Model: Paper Feed Unit PB3150	Date: 26-Jun-13	No.: RD694001b
--------------------------------------	-----------------	----------------

Model: Paper Feed Unit PB3150		Date: 03-Apr-18	No.: RD694002
Subject: Part catalog correction: Guide plate for PB3150/PB3160/PB3170/PB3230		Prepared by: H.Kameda	
From: Technical Support Sect., Product Marketing Dept.			
Classification:	<input type="checkbox"/> Troubleshooting <input type="checkbox"/> Mechanical <input type="checkbox"/> Paper path <input type="checkbox"/> Product Safety	<input checked="" type="checkbox"/> Part information <input type="checkbox"/> Electrical <input type="checkbox"/> Transmit/receive <input type="checkbox"/> Other ()	<input type="checkbox"/> Action required <input type="checkbox"/> Service manual revision <input type="checkbox"/> Retrofit information <input type="checkbox"/> Tier 2 <input type="checkbox"/> Tier 0.5

Parts catalog correction1

Affected model: D694 (Paper Feed Unit: PB3150)

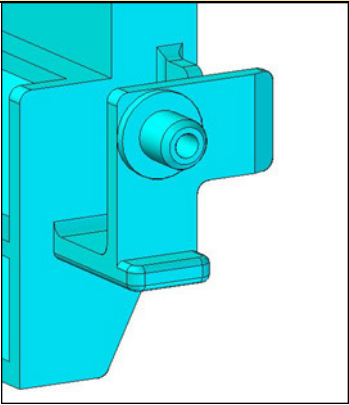
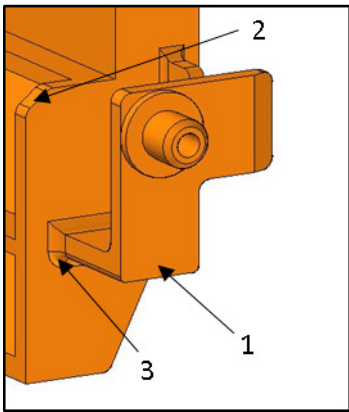
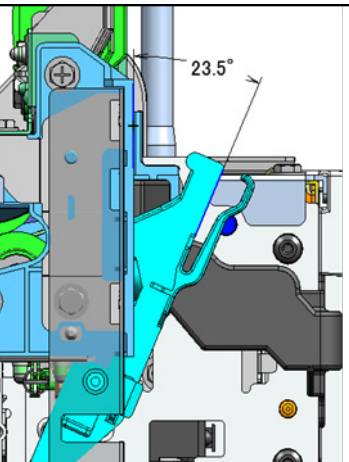
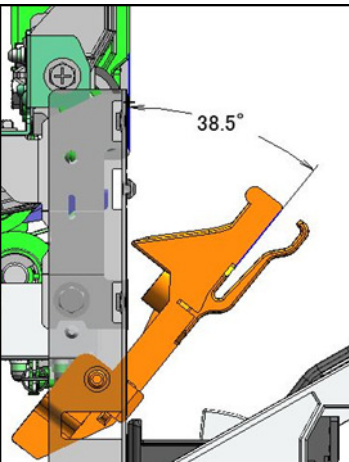
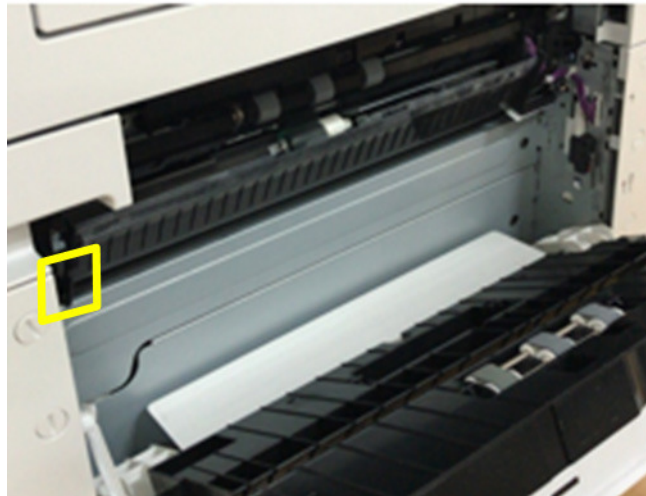
Old P/N	New P/N	Description	Q'ty	Int
D1492721	D6942721	GUIDE PLATE: SWIVEL	1-1	X/O

Change: The shape of the guide plate was changed.

Reason: To further strengthen and prevent breaking of the guide plate.

Old D1492721	New D6942721
Shape		 <ol style="list-style-type: none"> Deleted stopper Changed angle regulation Strengthened part
Angle

Parts catalog correction 2

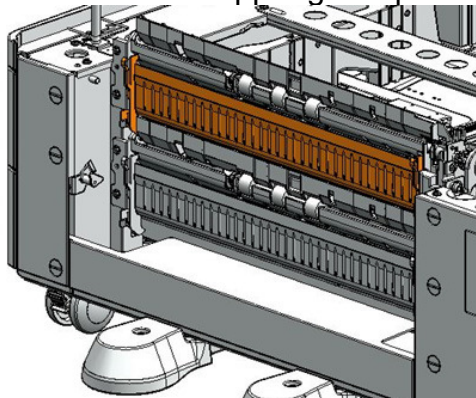
Old P/N	New P/N	Description	Q'ty	Int	Int
D6932526	D6932581	GUIDE PLATE:SWIVEL:No.3	1-0	X/O	X/O
	D6931157	CUSHION:GUIDE:SWIVEL:UP PER	0-1	-	-
	-	GUIDE PLATE:SWIVEL:NO.3	0-1	-	-
D6932725	D6932726	GUIDE PLATE:AUXILIARY:PAPER FEED UNIT	1-1	-	O/O

Change: Added cushions and changed the shape of the guide plate.

Reason: To further strengthen and prevent breaking of the guide plate.

Important: Be sure to attach the above CUSHION when installing the paper guide plates.

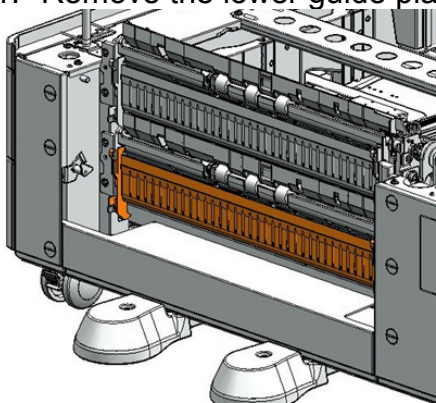
Old P/N	New P/N	Description	Q'ty	Int
D6932526	D6932582	GUIDE PLATE:SWIVEL:No.3	1-0	X/O
	D6931257	CUSHION:GUIDE:SWIVEL:LOWER	0-1	-
	-	GUIDE PLATE:SWIVEL:NO.3	0-1	-

Change: Added cushions and changed the shape of the guide plate.

Reason: To further strengthen and prevent breaking of the guide plate.

Important: Be sure to attach the above CUSHION when installing the paper guide plates.

Parts catalog correction 3

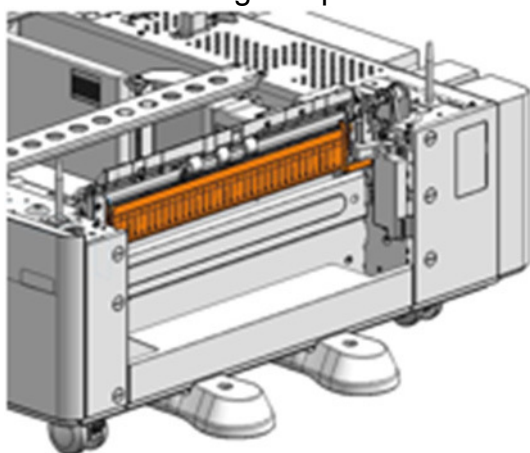
Old P/N	New P/N	Description	Q'ty	Int
D6932526	D6952581	GUIDE PLATE:SWIVEL:No.3	1-0	X/O
	-	STOPPER:GUIDE PLATE:SWIVEL:ASS'Y	0-1	-
	-	GUIDE PLATE:SWIVEL:ADHESION	0-1	-

Change: Added cushions and changed the shape of the guide plate.

Reason: To further strengthen and prevent breaking of the guide plate.

Important: Be sure to attach the above STOPPER, when installing the paper guide plates.
